DEVIATION REQUEST AND DECISION FORM

Project Name: Forest Heights Estates

PCD File No. MS206

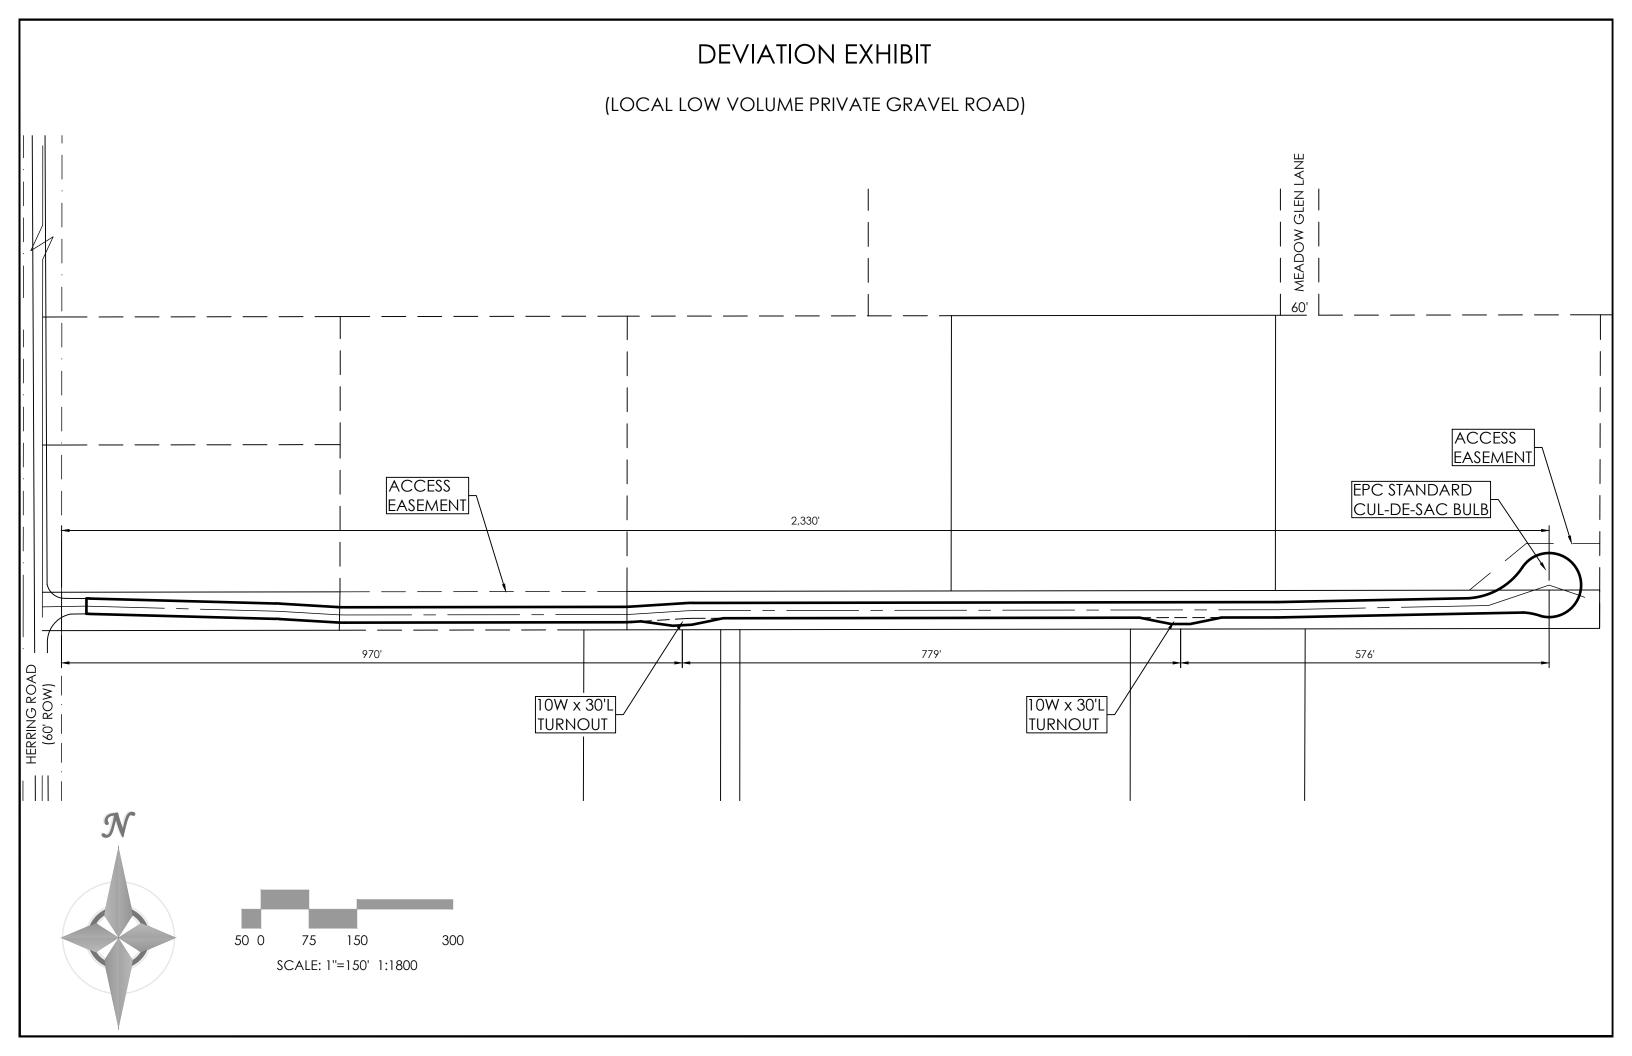
as basis):
The existing cul-de-sac termination for the private Forest Heights Circle roadway is located approximately 2,330 feet from the easterly Herring Road rigth-of-way line. The cul-dec length exceeds the ECM standard of 1,600 feet by 730 feet.

The existing roadway will be improved with consistent cross section and new gravel surface as well as enlargement of the cul-dac bulb to El Paso County standard dimensions.

The four new lots of Forest Heights Estates plus the six exisiting residences currently using private Forest Heights Circle will access the proposed cul-de-sac roadway.

Black Forest Fire Department has issued a letter consenting to the cul-de-sac roadway with the addition of two turn-outs with wider dirvable surface.

The cul-de-sac roadway is shown on the attached exhibit.
